Access Compliance Report

Public Rights-of-Way

Intersection ID: 13714	Main Street: HANOVER_ST	Cross Street: MCCLINTOCK_RD	Location: S
ADA ID: 3C3940157AE0	Ramp Type: BlendTrans1	Initial Pass/Fail: Fail	Overall Compliance: No
		Severity Score: 1.25

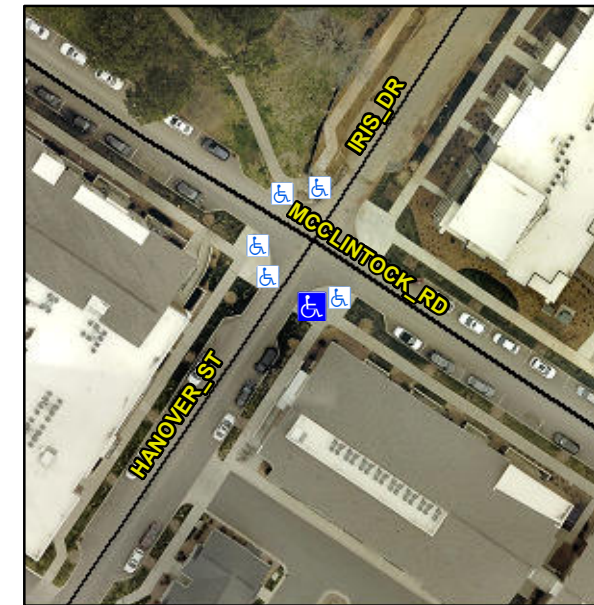
Not Found, R304.5.3

Compliance	Description	Data	Compliance	Description	Data
N/A	Ramp Length (in)	71.0	Yes	BlendTrans Slope (%)	1.6
Yes	Ramp Width (in)	68.5	No	BlendTrans XSlope (%)	3.7
N/A	Flare Type LT	N/A	N/A	Flare Type RT	N/A
N/A	Flare Slope LT (%)	N/A	N/A	Flare Slope RT (%)	N/A
N/A	Flare Traversable LT?	N/A	N/A	Flare Traversable RT?	N/A
N/A	Landing Length (in)	N/A	N/A	DWS Provided?	N/A
N/A	Landing Width (in)	N/A	N/A	DWS Contrast?	N/A
N/A	Landing Slope (%)	N/A	N/A	DWS Length (in)	N/A
N/A	Landing X Slope (%)	N/A	N/A	DWS Full Width?	N/A
N/A	Landing Curb? (Y/N)	N/A	N/A	DWS Offset (in)	N/A
N/A	Shared Landing?	N/A			
N/A	Gutter Ponding?	N/A	N/A	Gutter Slope (%)	N/A
N/A	Gutter Lip Ht (in)	N/A	N/A	Gutter X Slope (%)	N/A
N/A	Painted X Walk1?	No	N/A	Painted X Walk2?	N/A
	X Walk 1 Direction	To NW		X Walk 2 Direction	N/A
	X Walk 1 Width (in)	N/A		X Walk 2 Width (in)	N/A
	X Walk 1 Slope (%)	2.8		X Walk 2 Slope (%)	N/A
	X Walk 1 X Slope (%)	3.3		X Walk 2 X Slope (%)	N/A

N/A	Ramp inside XWalk1?	N/A	N/A	Ramp inside XWalk2?	N/A
	Road Slope (%)	3.3		Clear Space?	N/A
	Road X Slope (%)	2.8	N/A	Clear Space to XWalk (in)	N/A
N/A	Any Obstructions?	N/A	N/A	Storm Grate/Utility Hazard?	N/A
	Obstruction Type			Storm Grate/Utility Type	
		N/A			N/A
			Yes	Surface Condition? (G/P)	Good
			No	Curb Slope (%)	8.3

Remove & Replace Curb Ramp With Two New Directional Ramps or Equivalent.
